PARKSIDE MONTESSORI MPR AND SITE PROJECT

ADDENDUM NO. 2

Date: November 6, 2023

Project: Parkside Montessori MPR & Site Project
DSA #: 01-120306 41-26

12. SHEET ‘L3.1 IRRIGATION PLAN’

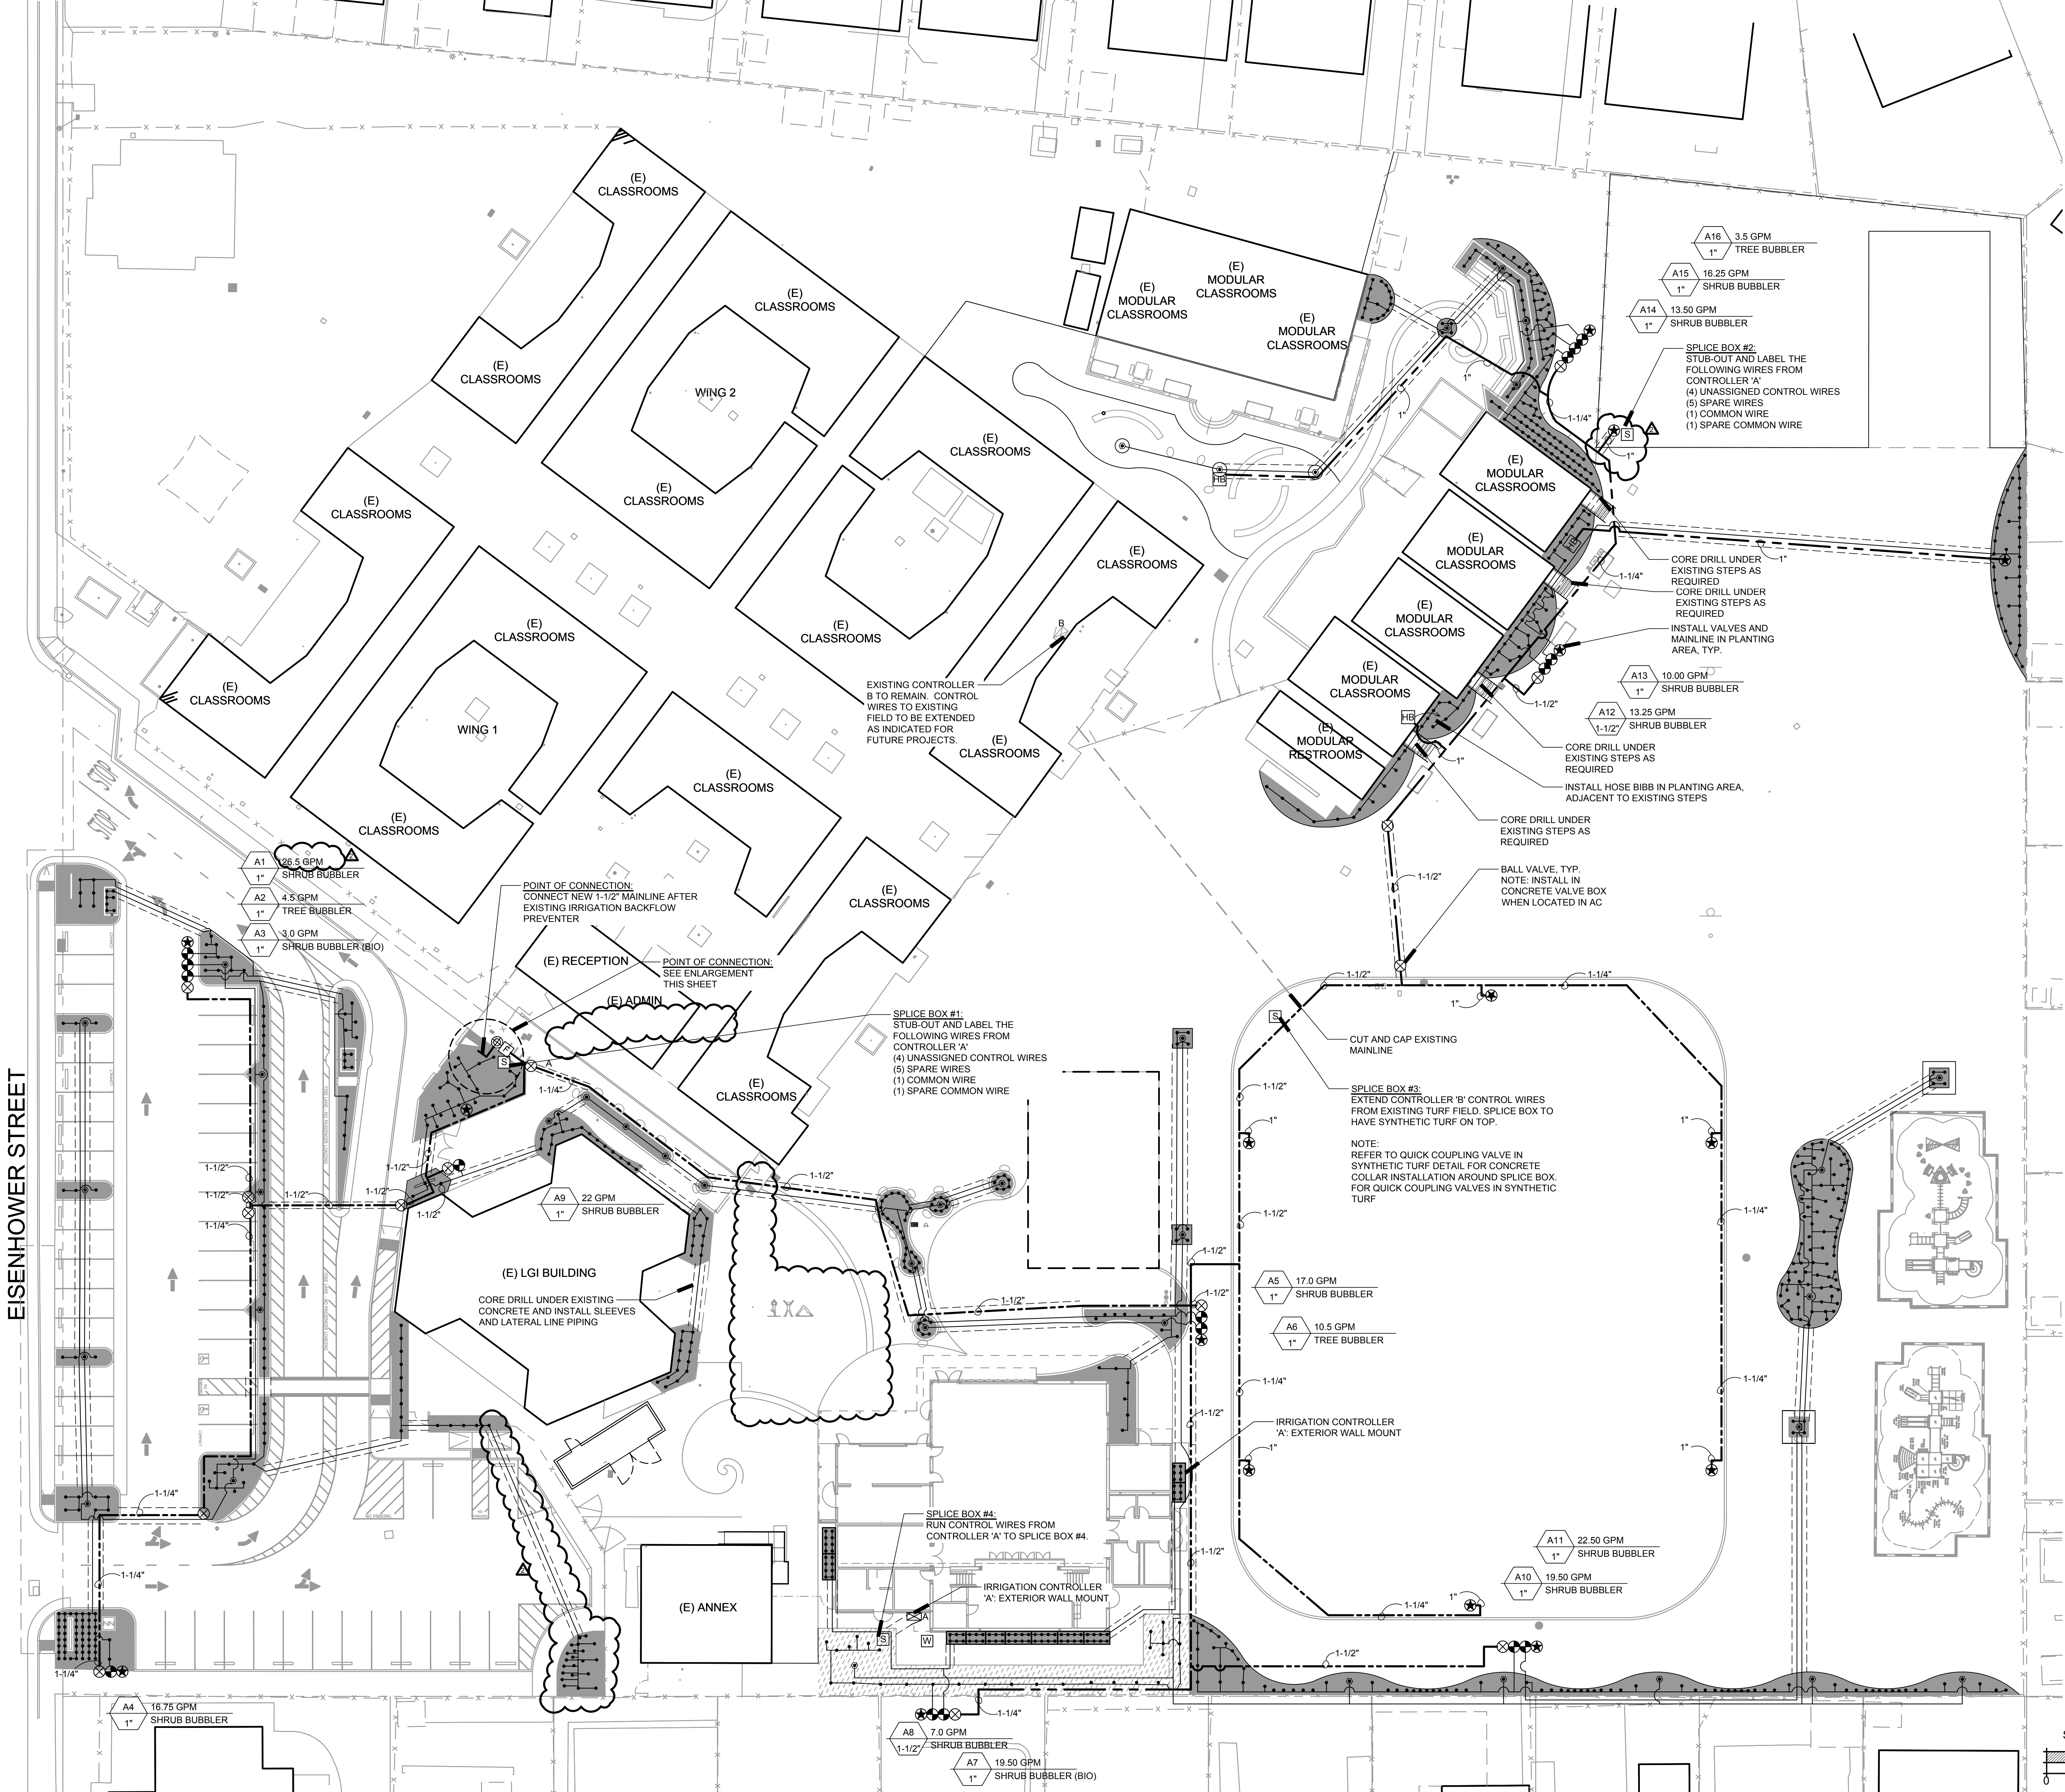
- A. Added irrigation to added landscape area near existing Annex Building.
- B. Deleted notes for bid alternate. All scope is part of base bid.

16. SHEET 'A1.1 CAMPUS SITE PLAN'

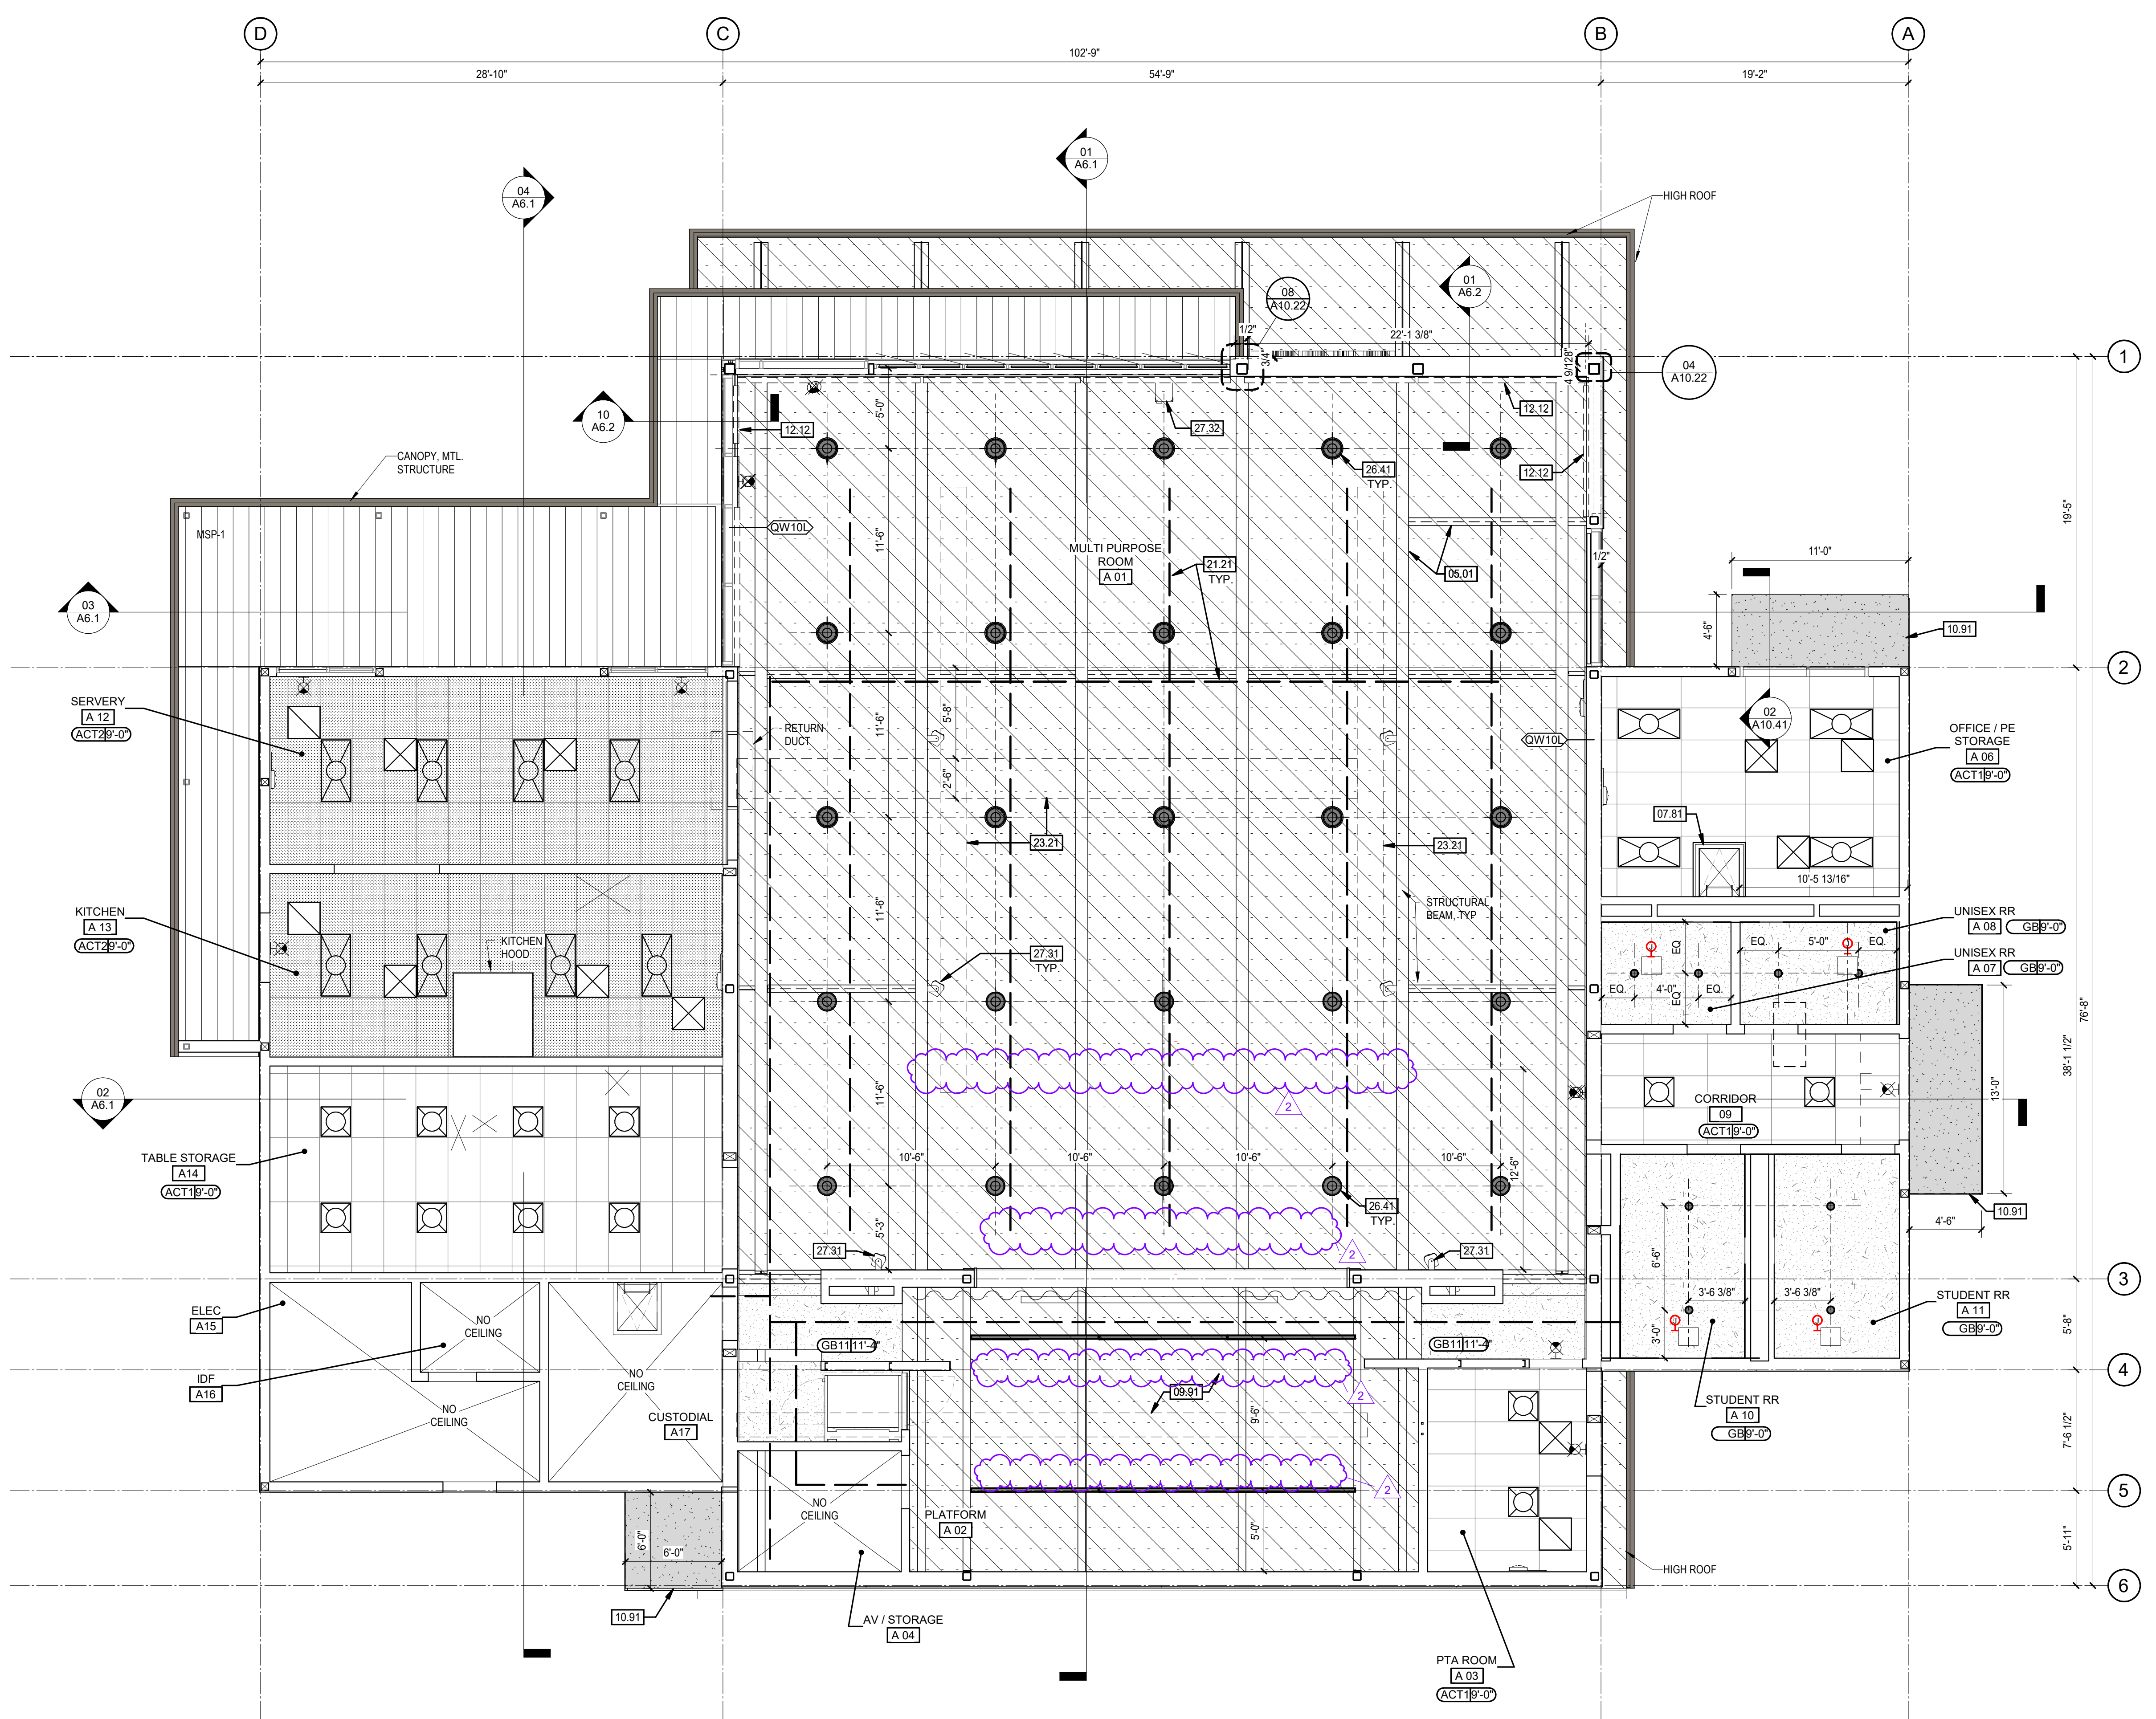
- A. Updated landscape and hardscape areas for expanded scope and to match landscape drawings.
- B. Deleted Add Alternate 1 Concrete paving and landscape areas. Scope shall be part of base bid. There are no bid alternates in this project.

20. SHEET 'A10.03 EXTERIOR STAIR DETAILS'

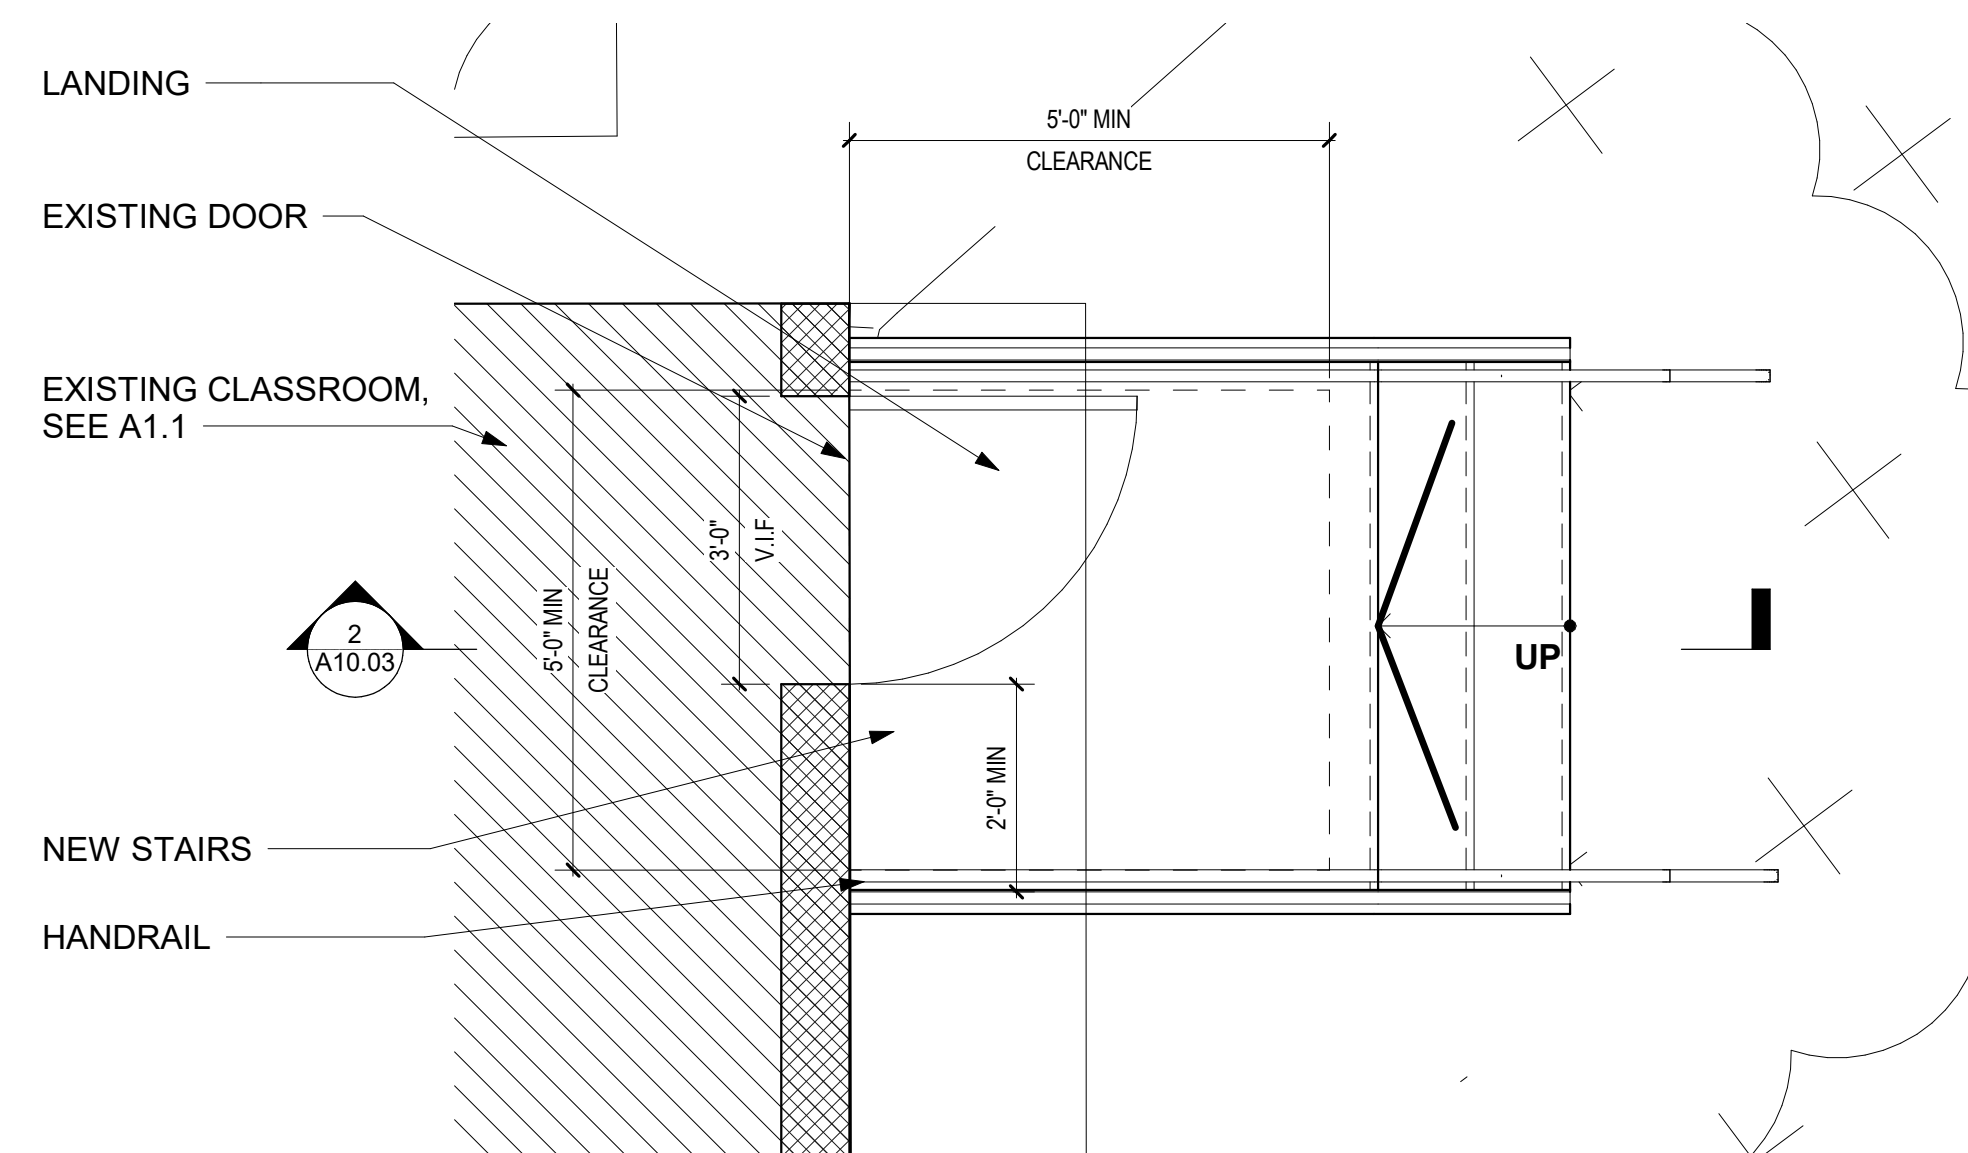
- A. Added prefab stair requirement details.
